CERTIFICATE OF APPROPRIATENESS PLACARD

403 ELM STREET

Raleigh Historic Development Commission - Certificate of Appropriateness (COA) Application

403 Elm Street Description of Work

Proposed West Elevation

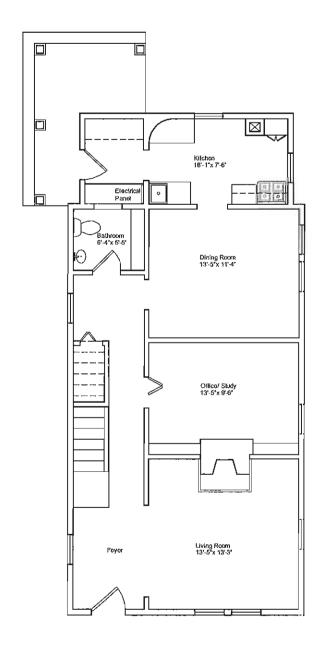
- muntin (grid) details for the new windows on the 2nd floor rear elevation
- confirmation that the trim details on the relocated and new windows and new doors will match the existing trim as shown in photos
- larger scale drawings of the rebuilt balcony

For the window muntins I need the specs from the manufacture. I can see from the drawings that the pattern is 9/1, but I am looking for the width and depth of the muntins and evidence that they are simulated divided lights, not simply grilles-between-the-glass or snap-in-muntins.

Here are the elevations that we submitted with new notes that state the upstairs grilles are 9 over 1 to match the existing windows along with the trim to match existing. The door trim will also match existing new note helps show this.

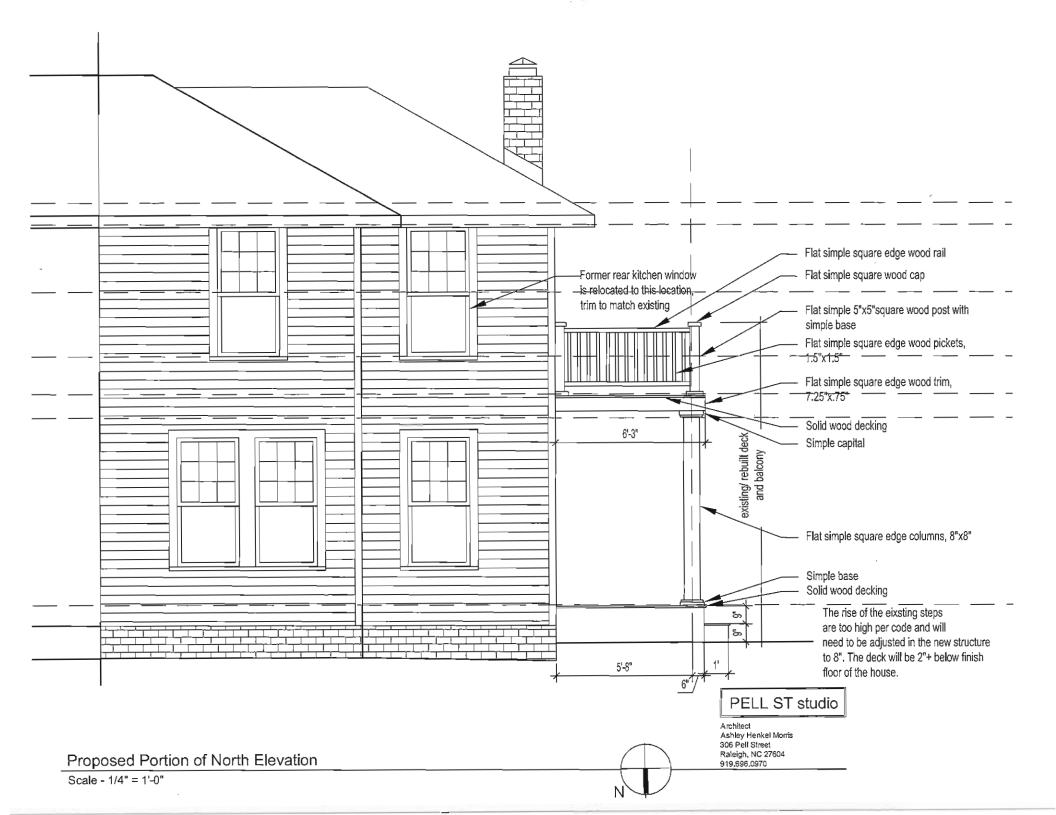
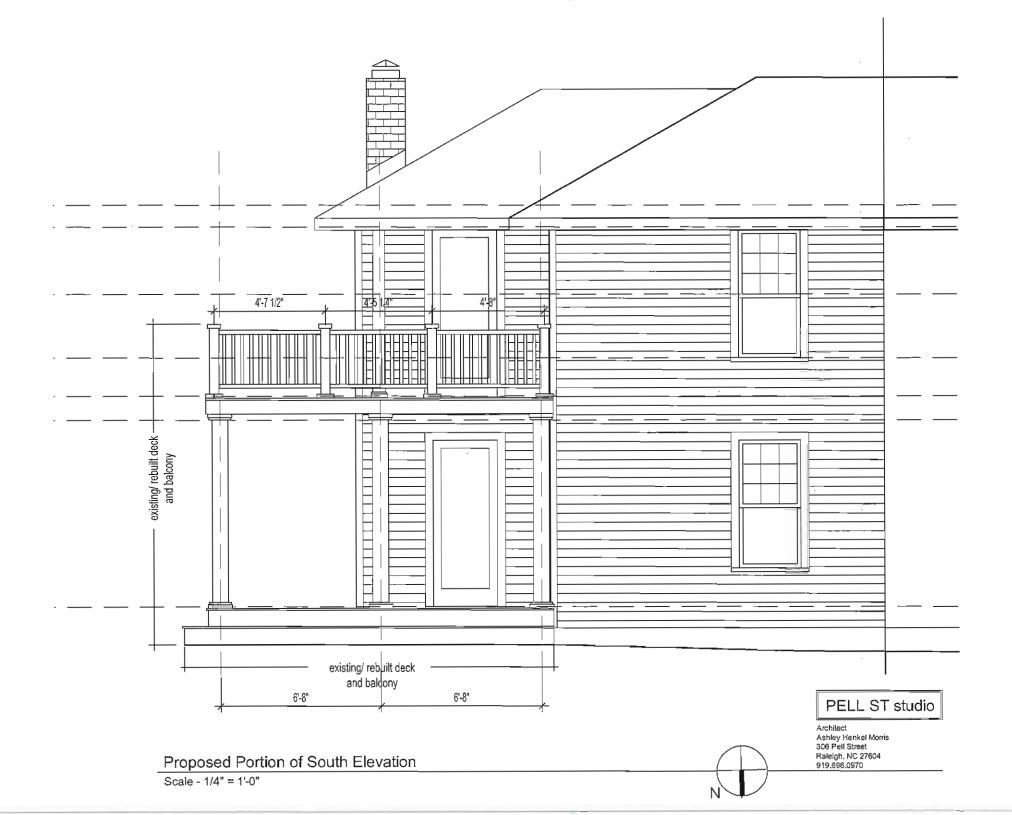
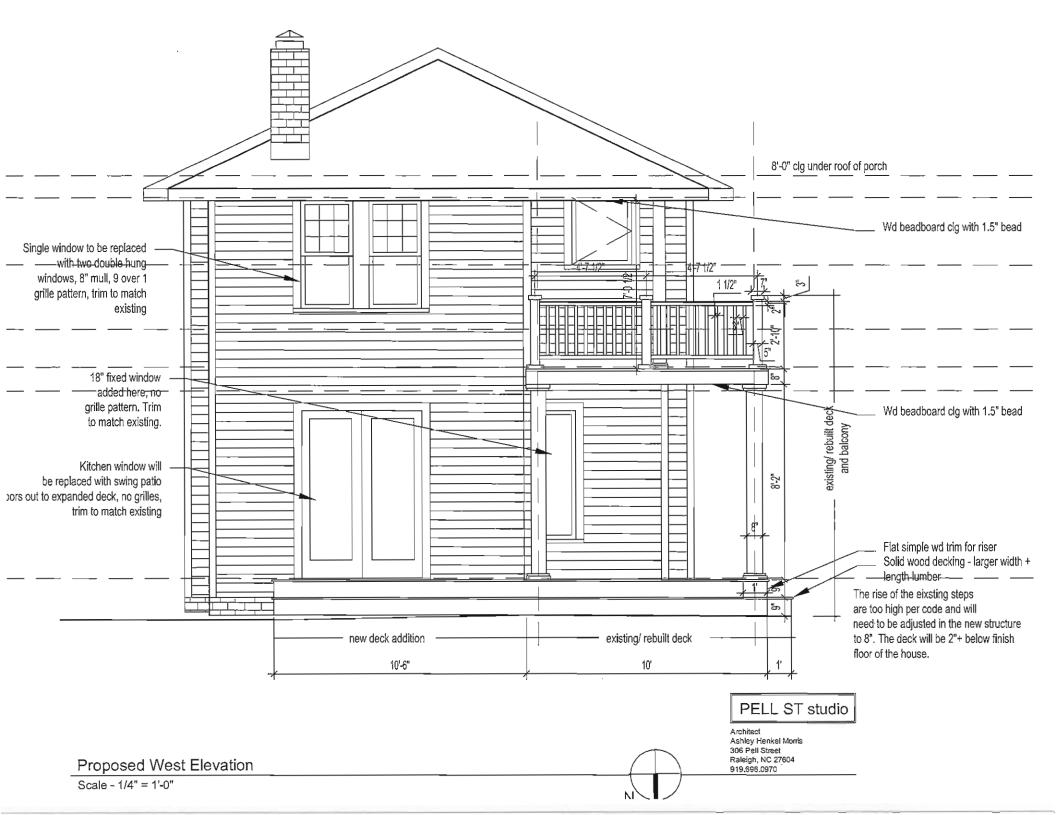
For the balcony, dims and notes detailing what is existing is perfect is that is what is being rebuilt.

See what you think about these and let me know if you need for me to add anymore info. I am still waiting on the window rep to send me his quote that will have all the info that you requested for the mutins etc.
